INITIAL FIRE SAFETY INSPECTION REPORT

AKH Outwear Ltd.

RSC ID: 26659

Fire Safety Inspection Report

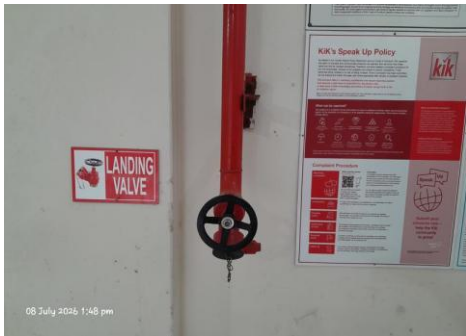
F-13	Fire Rated Construction	A non-rated connecting corridor (not used for horizontal exit) has been constructed between two buildings, which is not fire-separated from the adjacent building. Location(s): Between Production Building-1 & 2.	Separate the buildings with a minimum 2-hour fire-rated construction on both sides of the connecting corridor. Opening protection extending up to 10 feet beyond the connecting corridor shall meet section 4.6 of RSC Technical Guidelines (Standard).	Within 3 Months

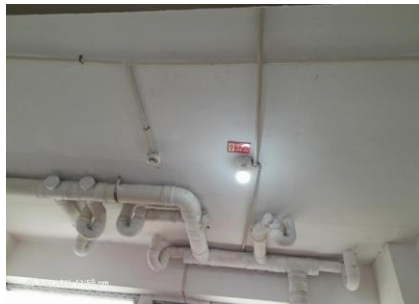
F-30	Means of Egress	The exit ramp slope ratio does not comply with the RSC Technical Guidelines (Standard). Location(s): Both exits, Production Building-2.	The construction of slope in the direction of travel shall comply with the RSC Technical Guidelines (Standard), Section 6.10.	Within 3 Months
